Project/File: 45th St. Lofts/ GCPP21-0007/ SUBFY2021-0008
 This is a subdivision and planned unit development application to allow for the development of 13-lots on 0.68 acres.

Lead Agency: Garden City
Site address: 304 E. 45th Street
Staff Approval: October 27, 2021
Applicant: Chrysalis Architecture
 Matt McNulty
 3914 E. Presidential Drive
 Meridian, Idaho 83642
Staff Contact: Renata Ball-Hamilton
 Phone: 387-6171

SITE PLAN

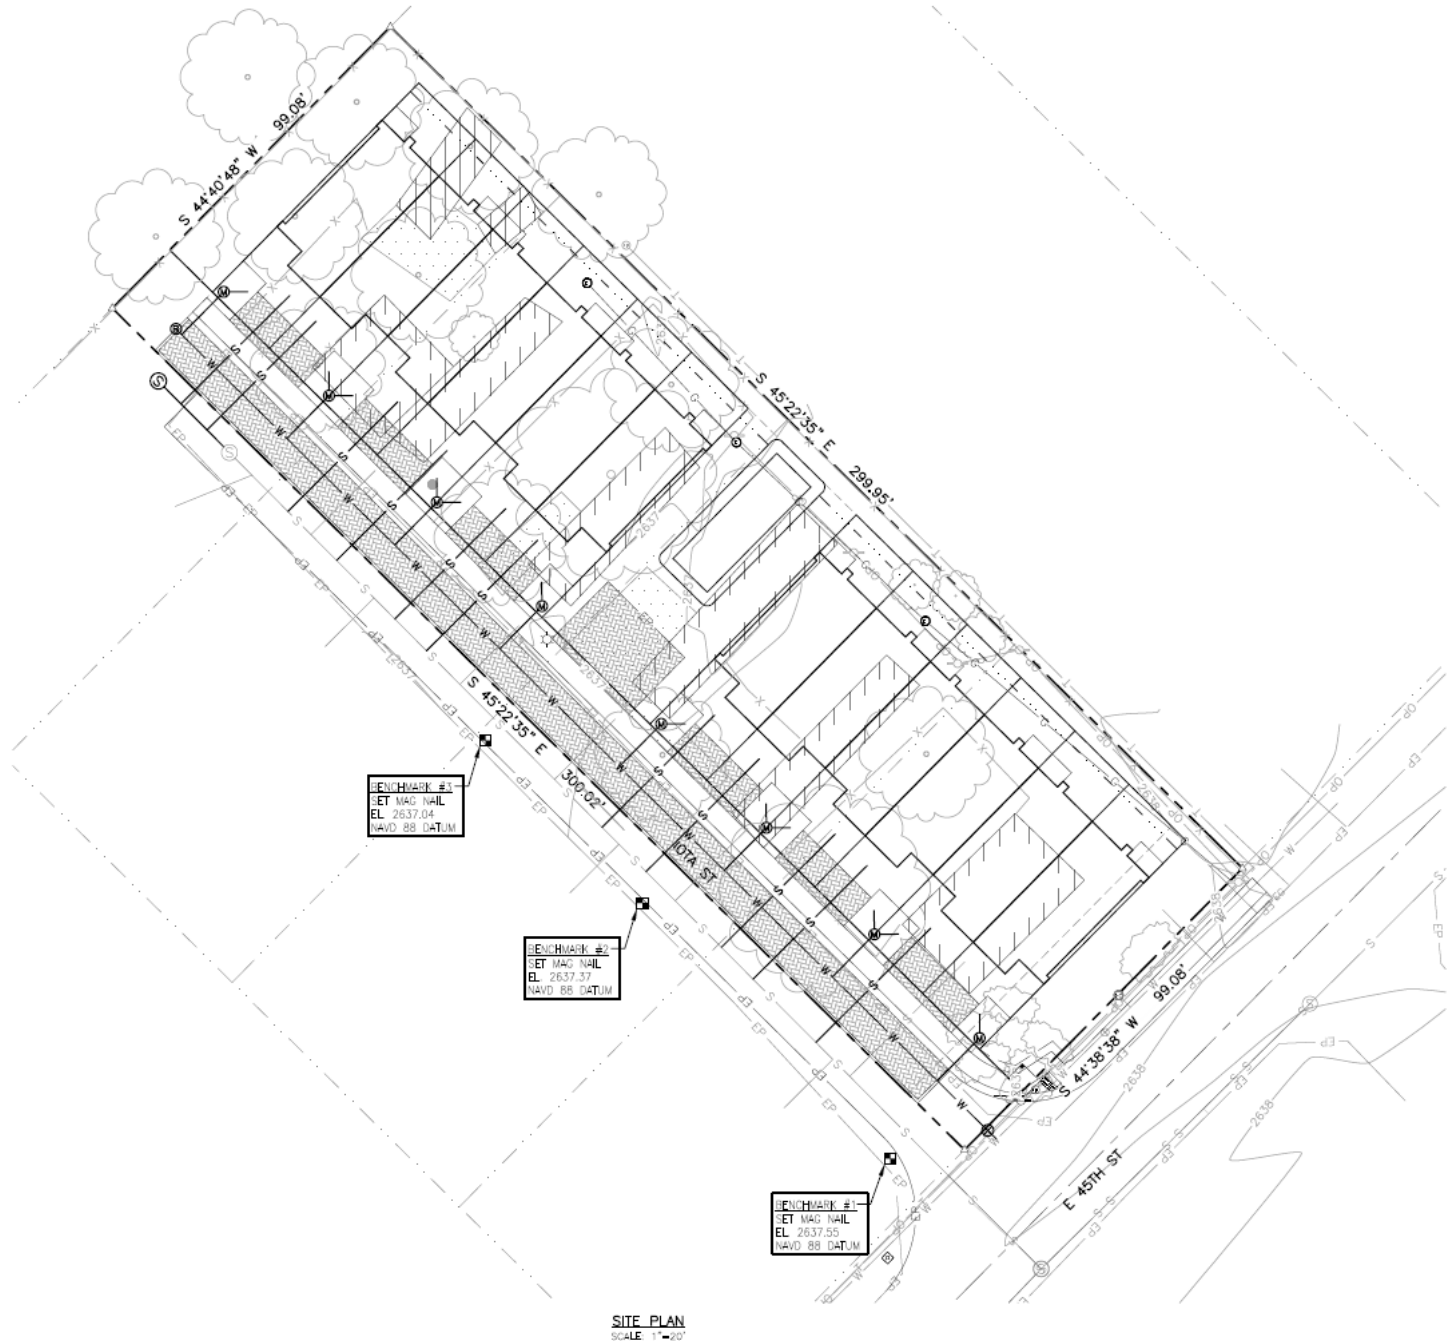
d. **Staff Comments/Recommendations:** The applicant's proposal to construct 45th Street as ½ of 33-foot local street section with pavement widening total 16.5-feet from the centerline, curb, gutter, and 5-foot wide attached concrete sidewalk within the existing 50-feet of right-of-way meets District policy and should be approved, as proposed.

The applicant's proposal to dedicate additional right of way to total 20.5-feet from the centerline of Iota Street meets District policy and should be approved, as proposed.

The applicant should construct Iota Street as ½ of 27-foot local street section with permeable pavement to total 13.5-feet from centerline, curb, gutter, and 5-foot wide concrete sidewalk meets District policy with the exception of the permeable pavers. The applicant should be required to construct Iota Street as half of 27-foot local street section with pavement widening to total 13.5-feet from centerline, curb, gutter, and 5-foot concrete sidewalk abutting the site.

- d. **Staff Comments/Recommendations:** The applicant's proposal to extend and reconstruct Iota Street into the site as half of a 27-foot wide local street section with 270-feet in length of new pavement, curb, gutter, and 5-foot wide attached concrete sidewalk, on the north side of the roadway at the site's southern property line, does not meet the District's Stub Street policy, which require stub streets to provide circulation or to provide access to adjoining properties. The applicant should be required to extend Iota Street completely to the site's northwest property line.

Iota Street is greater than 150-feet in length, therefore, to provide the public, emergency, delivery, or service vehicles with a place to turnaround at the terminus the applicant should be required to construct a hammerhead turnaround. This modification is supported by the District's Cul-de-sac Streets policy which states that the District will consider alternatives to the standard cul-de-sac turnaround on a case-by-case basis. The applicant should be required to provide written approval from the Garden City Fire Department for the use of the hammer head turnaround and coordinate the design of the hammer head turnaround with staff prior to plan submittal.

- d. **Staff Comments/Recommendations:** The applicant's proposal to close the four existing 18-foot wide curb cut type driveways from the site onto Iota Street meets District policy and should be approved, as proposed.

The applicant's proposal to construct six shared 22-foot wide permeable pavement curb cut type driveways from the site onto Iota Street located 59-feet, 97-feet, 135-feet, 213-feet, 251-feet, and 289-feet into the site from 45th Street does not meet the District's Driveway Width policy that states where vertical curbs are required, residential driveways shall be restricted to a maximum width of 20-feet and may be constructed as curb-cut type driveways.

However, staff recommends a modification of policy to allow the six proposed 22-foot wide permeable pavement curb cut type driveways to be the proposed 22-feet due to the fact that each driveway is shared and serves a proposed garage.

- c. **Staff Comments/Recommendations:** For this development, Iota Street acts essentially as a driveway, only serving 13-lots, provides no public benefit, and increases the long term maintenance costs for ACHD. For these reasons, and because the proposed street does not meet the District's Stub Street policy, staff recommends that the applicant vacate the right-of-way for Iota Street and construct Iota Street as a private road.

1. Construct 45th Street as ½ of 33-foot local street section with 2-travel lanes, curb, gutter, and 5-foot wide attached concrete sidewalk within the existing 50-feet of right-of-way abutting the site.

3. Construct Iota Street as ½ of 27-foot local street section (plus 12 additional feet of pavement to total 25-feet) with vertical curb, gutter, and a 5-foot wide concrete sidewalk on the north side of the roadway. The south side of the roadway should be improved with a 3-foot wide gravel shoulder and a borrow ditch sized to accommodate the roadway storm runoff.

6. Extend and reconstruct Iota Street into the site as ½ of a 2-lane, 27-foot wide Local Roadway with 270-feet in length of new pavement, curb, gutter, and 5-foot wide attached concrete sidewalk, located at the north side of the roadway at the site's southern property line.

8. Provide a public turnaround easement, to provide a T-type turnaround approved by the Garden City Fire Department.
9. Coordinate the design of the T-type turnaround with staff prior to plan submittal.

13. Construct 6 shared 22-foot wide concrete curb cut type driveways from the site onto Iota Street located 59-feet,97-feet. 135-feet, 213-feet,251-feet, and 289-feet north of 45th street.

14. Pave the driveway its full width and at least 30-feet into the site beyond the edge of pavement of Iota Street.
15. Construct 3 concrete onsite guest parking spots from the site onto Iota Street located 175-feet to the north of 45th Street.
